# P1450.4 meeting minutes - 11/12/03

## Agenda:

Figure 2B: SubFlow Module

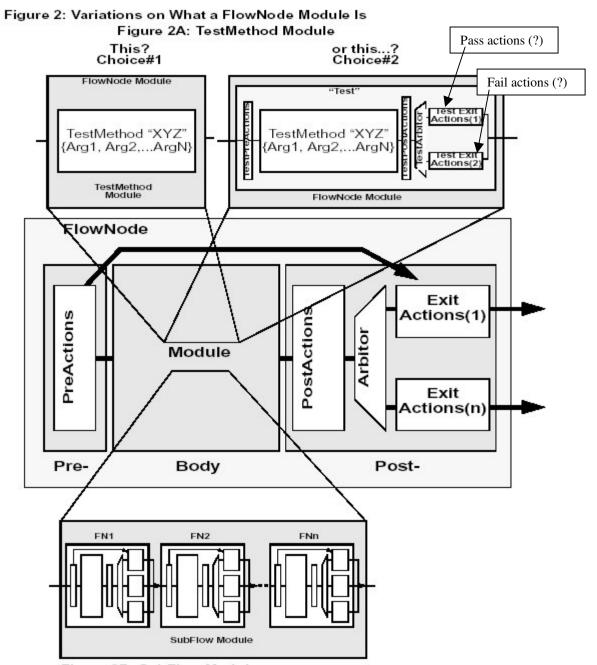
In the discussion of Fig. 2 (Fig 2a - choice 1 and choice 2), Ernie pointed out that choice 2 (since it is a test block, not a flow-node) should just have pass and fail exit actions, which (as shown) converge to a single exit point. Dave will update the diagram to reflect this. Ernie reiterated that, in his view, the body of flow-node is not an instantiation of a test, but should just be a **pointer** to a test method or a test.

I had the sense that, at the conclusion of the call, all present felt that, if we could develop reasonably clean syntax for the concepts represented in Fig. 2a, choice 2, and Fig. 2b, they'd be agreeable to that representation (I hope I haven't misrepresented anyone's postion!).
